Rezoning Transportation Analysis

Petition Number: 2026-024

Date	Description
04-23-26	First Review (CM)

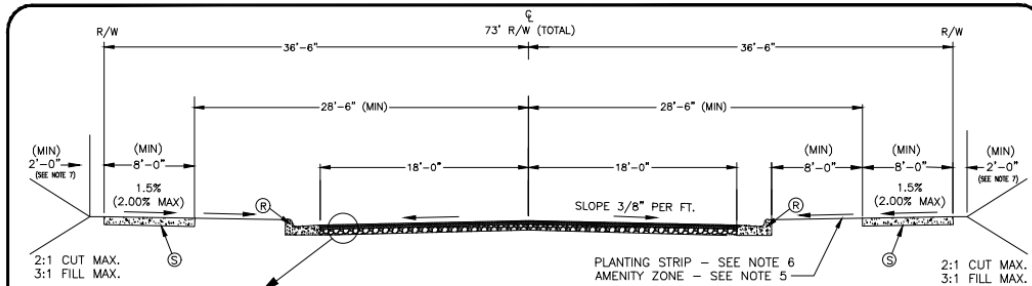
- a. **West Summit Avenue:** Location of future back of curb and gutter needs to be a minimum 17.5 feet from centerline of roadway. Existing curb and gutter is not required to be relocated.

Label and dimension the curb and gutter from the centerline for each road on the site plan.

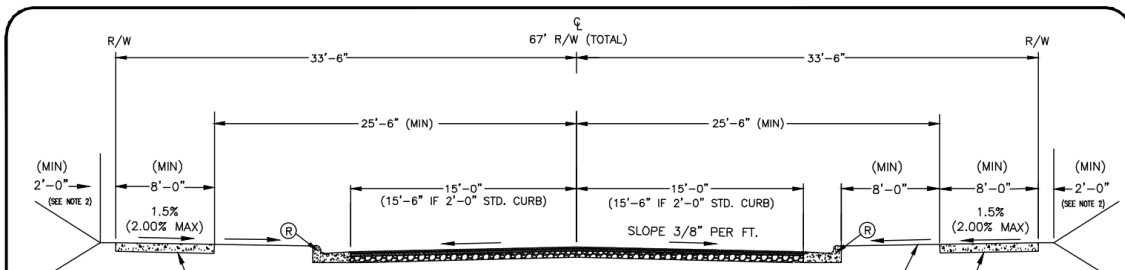
- b. **Merriman Avenue:** Location of future back of curb and gutter to be a minimum 20.5ft from centerline of roadway per CLDSM U-05. Existing curb and gutter is not required to be relocated.

Label and dimension the curb and gutter from the centerline for each road on the site plan.

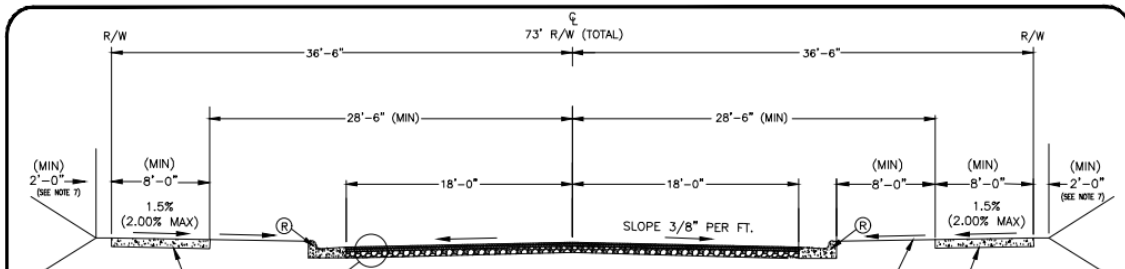
- c. **Spruce Street:** Location of future back of curb and gutter to be a minimum 17.5 feet from centerline of roadway per CLDSM U-03. Existing curb and gutter is not required to be relocated.

Label and dimension the curb and gutter from the centerline for each road on the site plan.

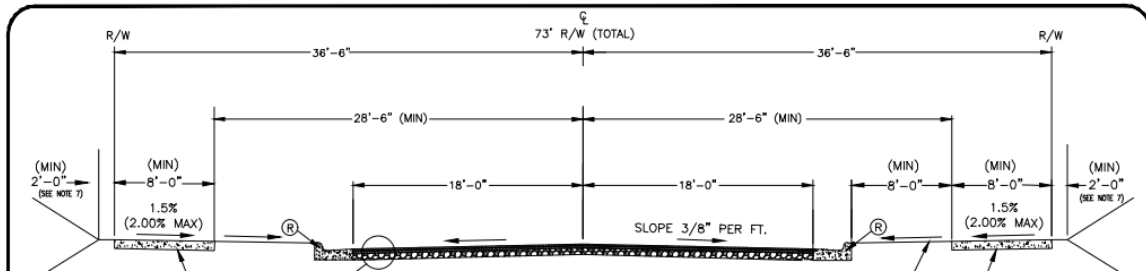
- d. **New Public Street A:** Location of future back of curb and gutter to be constructed a minimum 20.5 feet from centerline of roadway per CLDSM U-05.

Label and dimension the curb and gutter from the centerline for each road on the site plan.
